RE: **Response Letter Lisciotti Development – Site Plan Review** WS Orchard Street - New Bedford, Massachusetts

We have enclosed a response letter and revised Site Plans in response to the comment email prepared by Rudy Butros dated June 26, 2019 in regards to their review of the Site Plan Review Submittal.

— SITE PLAN — WS ORCHARD STREET ASSESSORS MAP 23 LOTS 158 & 294 NEW BEDFORD, MASSACHUSETTS

LAYOUT

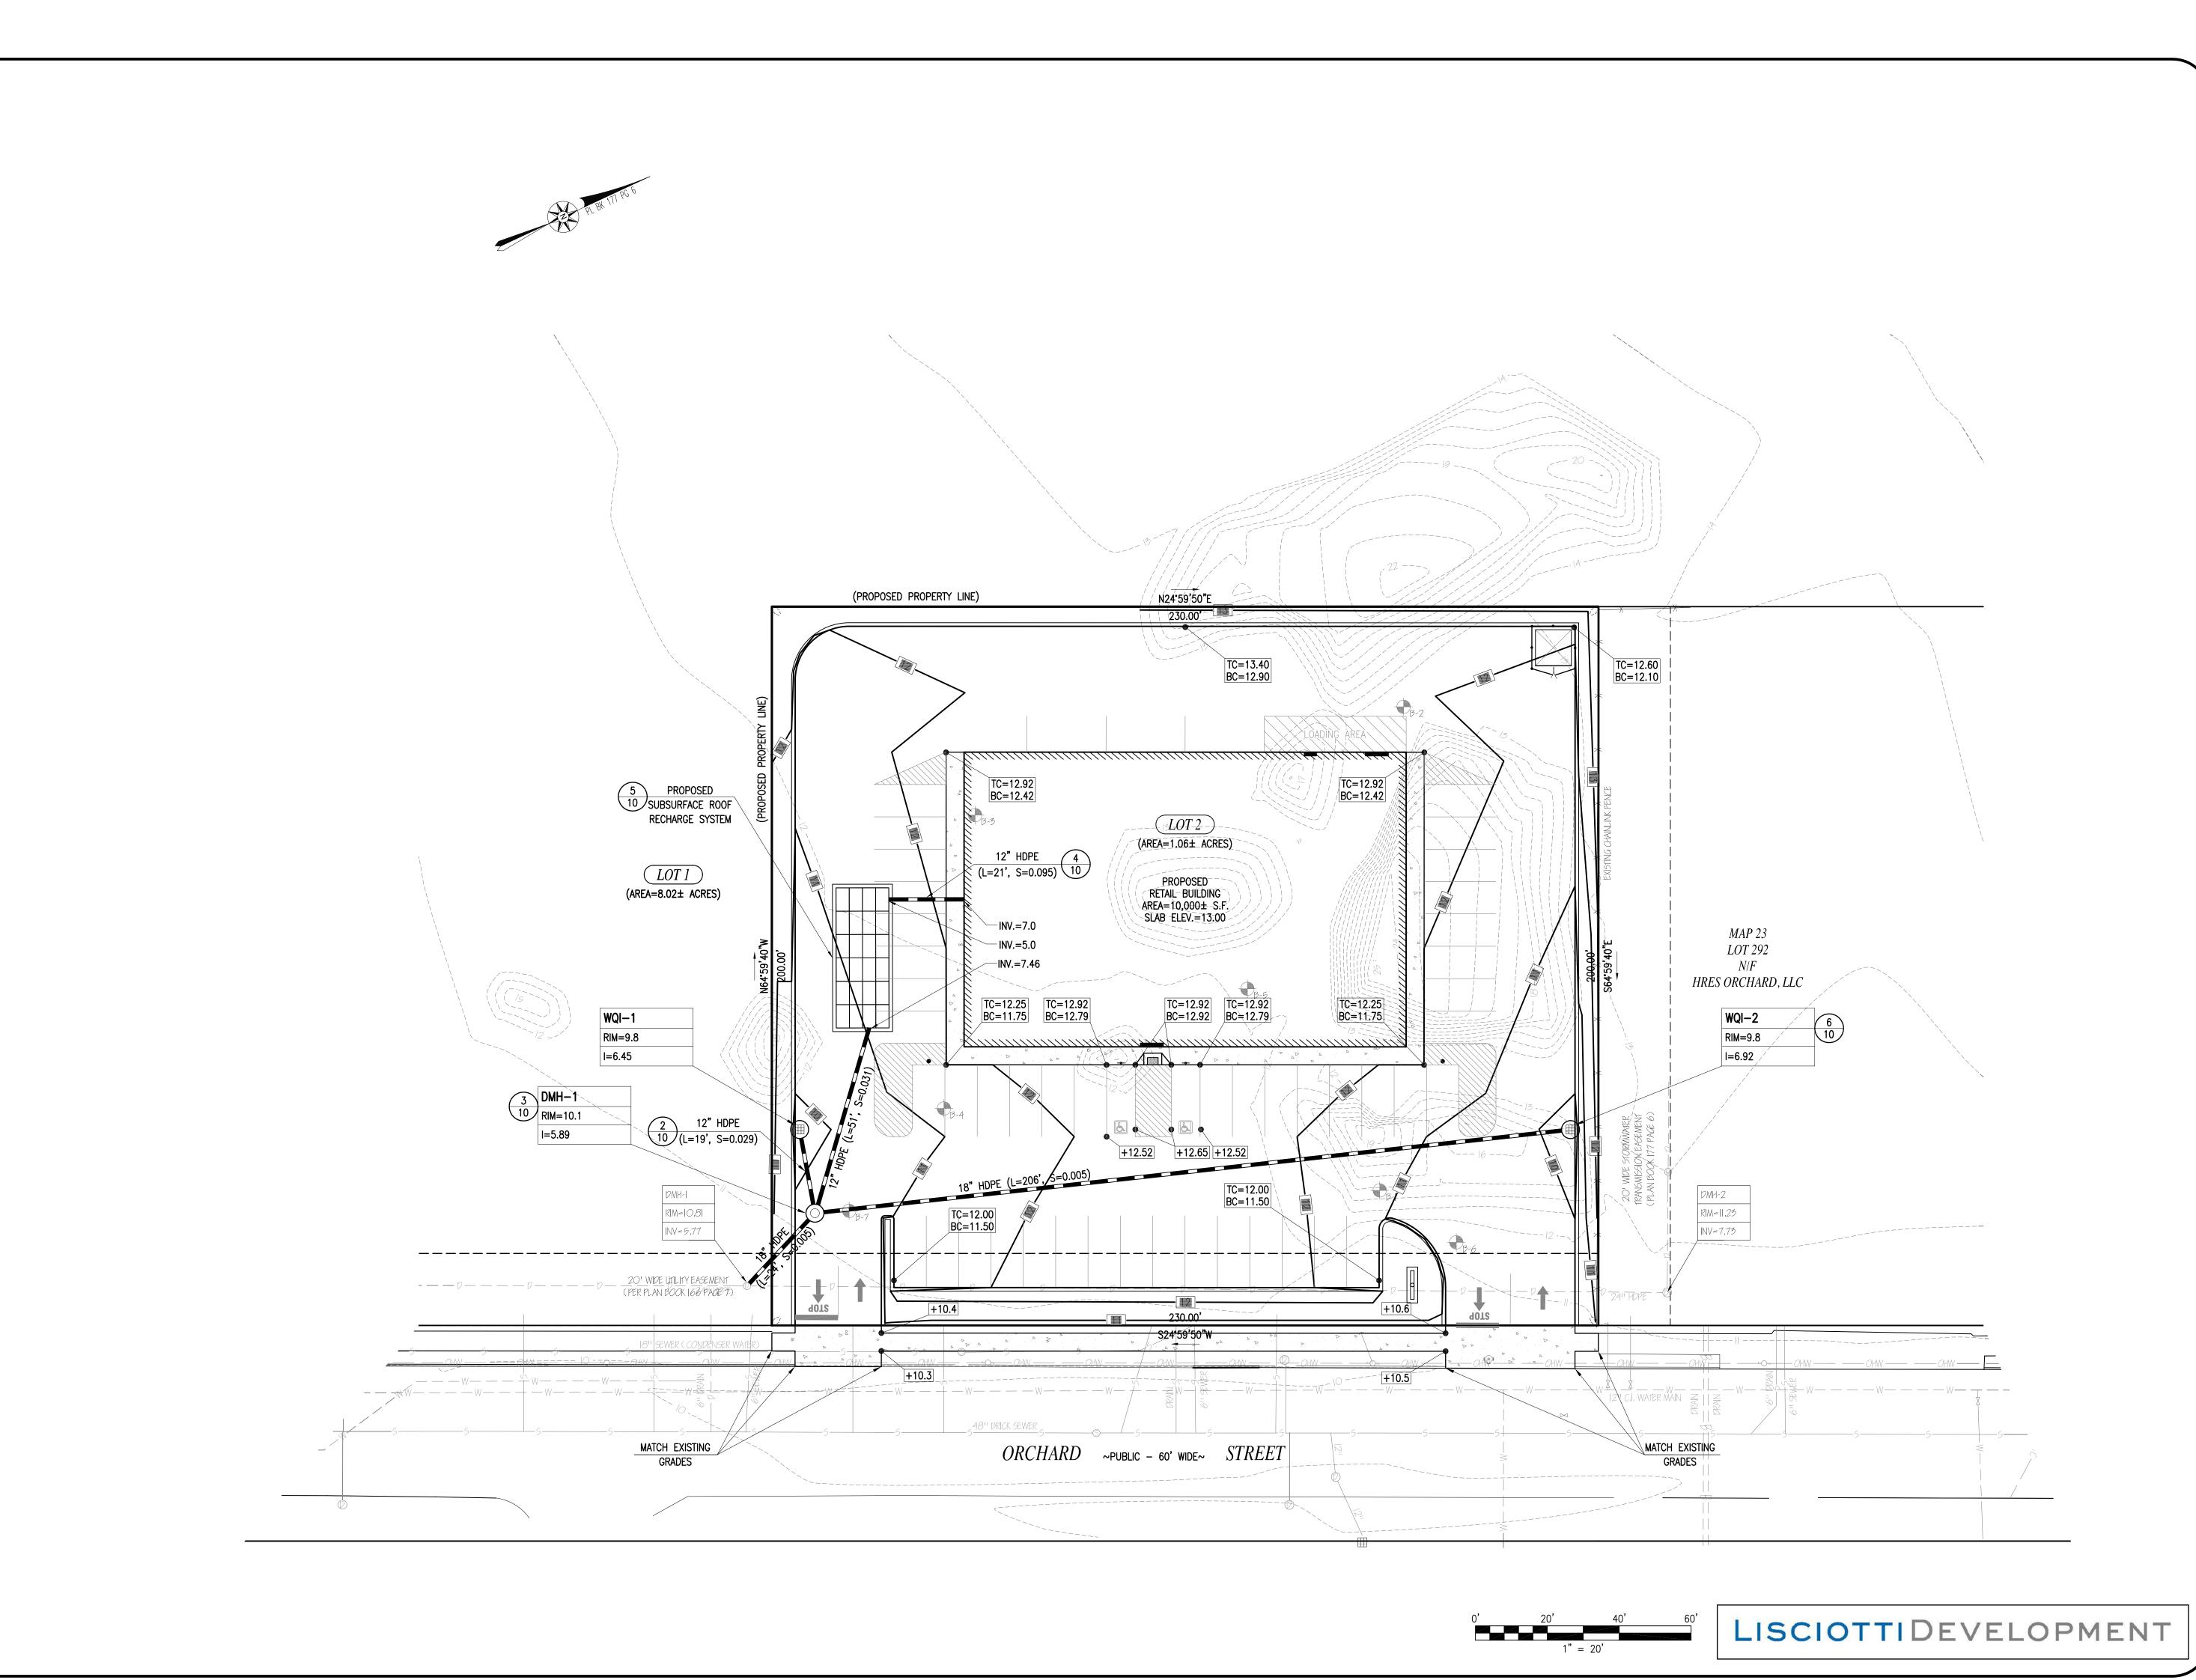
Is it possible to stripe the loading area since there will be other parking spaces planned in the rear?

Are there other opportunities to expand the landscaped areas?

City ordinance requires parking spaces to be 9' by 20', parking lot aisles to be at least 22', site plan shows 9' by 18' spaces. Are there plans to request a waiver?

The site plan has been revised to show striping in the rear where the loading area is proposed.

The proposed painted parking islands within the site can be revised to be raised landscaped islands per the board's request. This would not affect truck maneuvers through the site.

The site plans have been revised to show spaces with dimensions of 9'x20' and aisle widths of 22' as required by city ordinance.

SHEET 6 OF 10

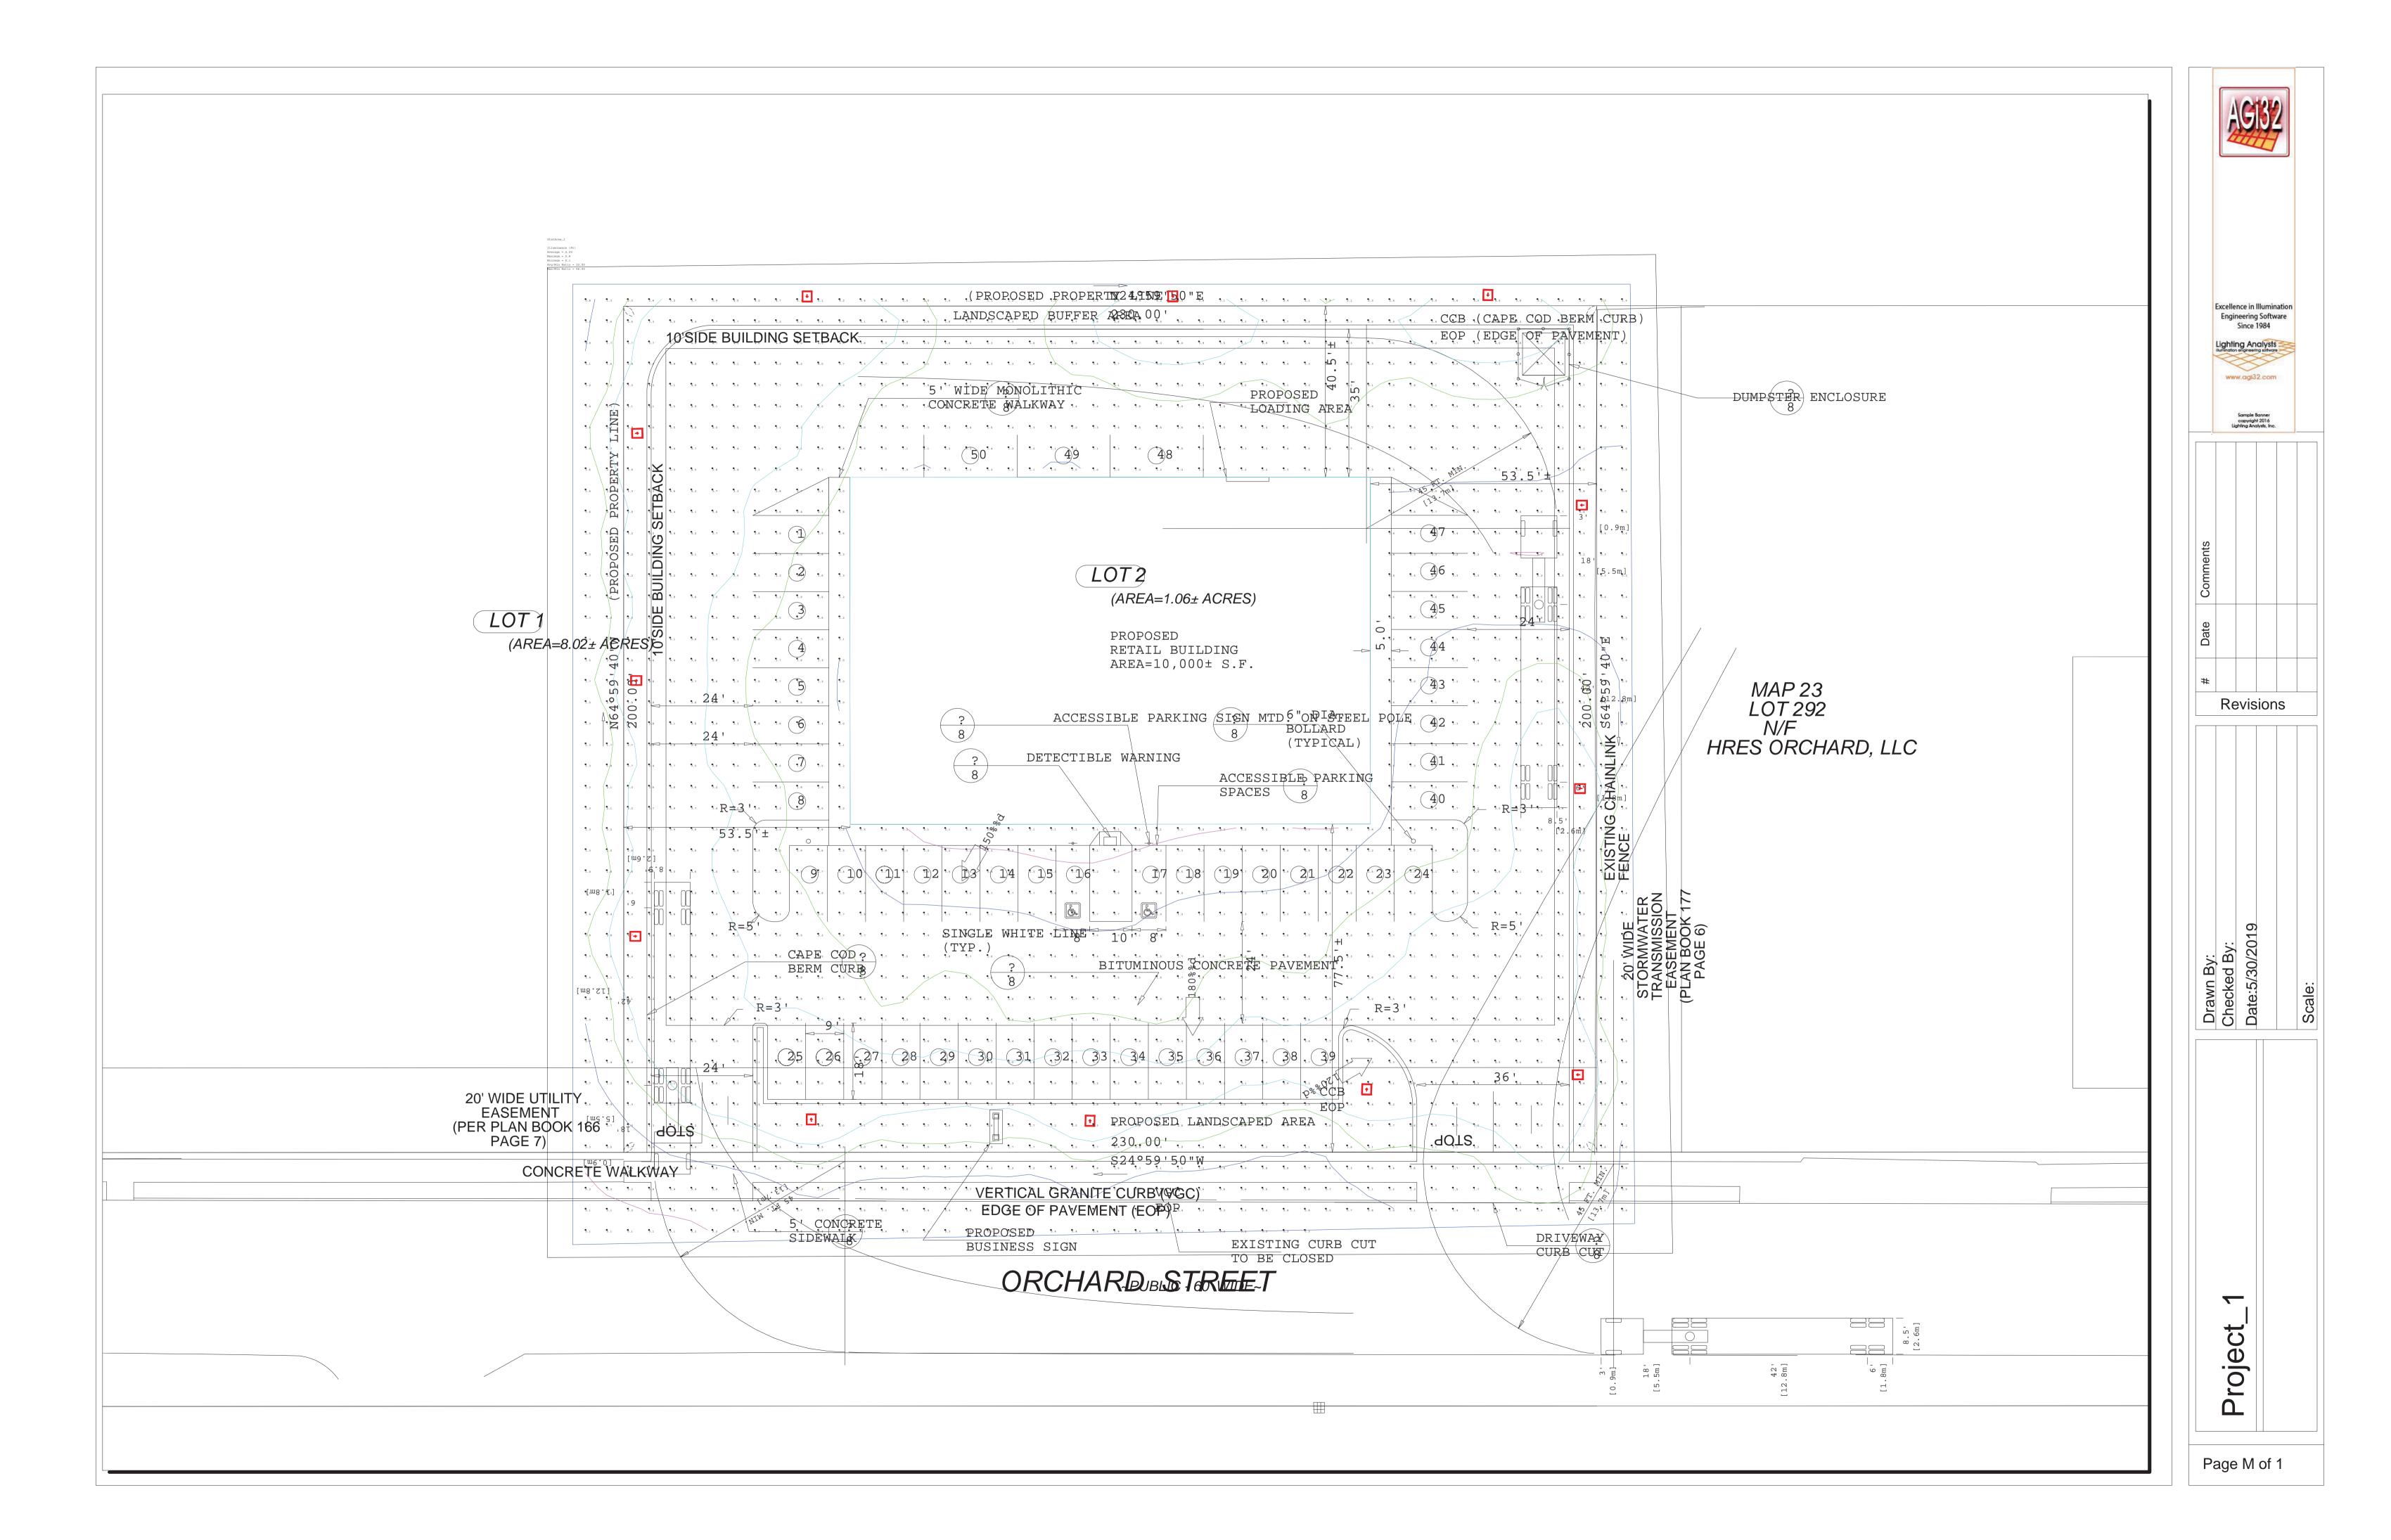
Landscaped areas on the north and south side of the lot are 5' wide, while fully mature Blue Spruce trees can have much wider diameter, have they considered this?

Planting species were chosen based off similar projects in the vicinity, however the Blue Spruce trees have been replaced with Common

Hornbeam to reduce the amount of encroachment when full maturity is reached.
